Final Modification Report

CMP432: Improve "Locational Onshore Security Factor" for TNUoS Wider Tariffs

Overview: This modification seeks to improve the cost reflectivity of transmission charging methodology by removing the "Locational Onshore Security Factor", so that Wider locational Transmission Network Use of System (TNUoS) charges better reflect the way Transmission Owners (TOs) plan for a secure network based on the Security and Quality of Supply Standard (SQSS) requirements.

The graph below illustrates how the Original solution separates out the sunk cost of security in the existing network, so that only the incremental cost of security is applied to price signals reflecting the incremental cost of expansion. This results in a more reflective Security Factor of "1.0".

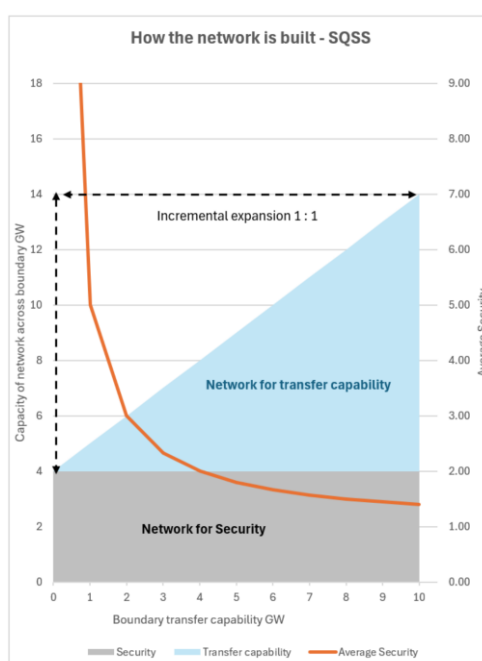
The Proposer presented to the Workgroup for discussion, the additional graphs that were included in SSE's Workgroup Consultation response. The Proposer explained that the graphs provide an illustration in terms of economic theory behind the Original solution. The rationale is that the GB Transmission System is already secure and SQSS system security relates to fault conditions at an absolute level, which means that the GB Transmission System is already secure, so when increasing the network transfer capability, no additional security is required. By contrast SQSS fault conditions do not relate to a factor of the network capacity.

The Y-axis shows the total thermal capacity of circuits crossing any given boundary. The X-axis shows the boundary transfer capability of the same boundary. The Y-axis on the right-hand side shows the average security which is the Y-axis divided by the X-axis.

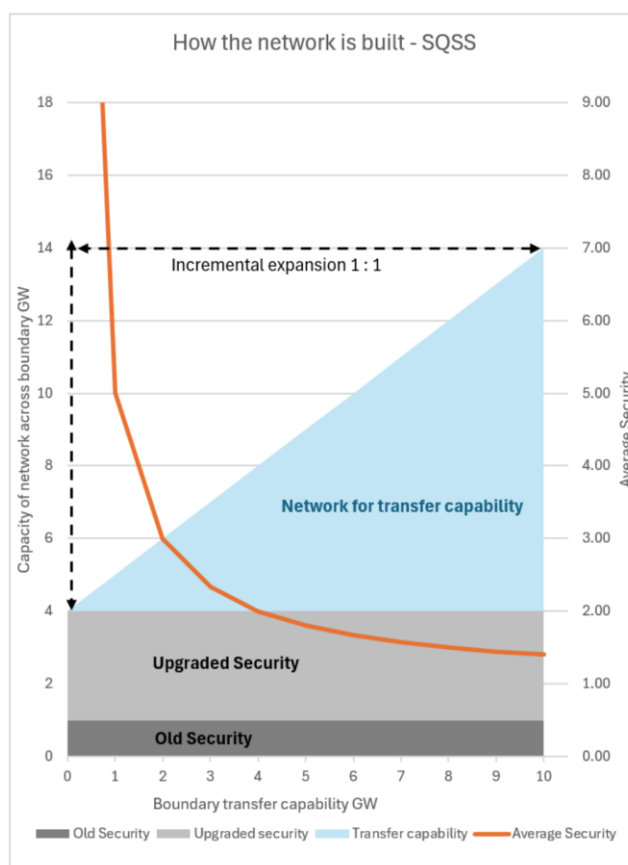
The Proposer further explained their view that as part of the GB societal objective to deliver Clean Power 2030 Action Plan and Net Zero, a decision has been made to upgrade the level of security in some parts of the network, such as Northern Scotland, in order to be able to accommodate the growth of renewable generation in that area. In the case, of upgrading of security from an old low level to a new higher level, with an increase in size of the fault condition reflects a one-off step change increase in the security level of the network. This cost of upgrading security is a sunk cost because this cost will not vary with the degree of expansion of the network to accommodate more, or less renewables generation in the future. Therefore, the appropriate incremental Security Factor remains "1.0" for such areas of the network upgrade. This step-change increase in security is illustrated in the graph below.

How Baseline TNUoS assumes the network is built

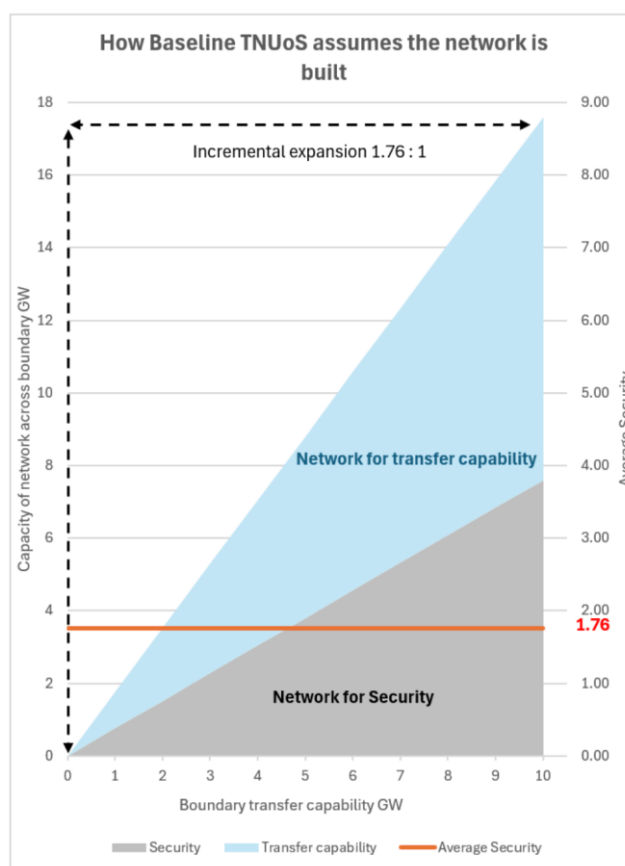
The Proposer contrasted this with the baseline TNUoS methodology, which, in the Proposer's view, incorrectly assumes that the cost of security always increases proportionately with the expansion of network transfer capacity. It does this by incorrectly charging the current average level of security as if it is an incremental cost, which it is not. The Proposer presented the graph below suggesting this illustrates how the baseline charging methodology incorrectly assumes that security is provided in proportion to network expansion.
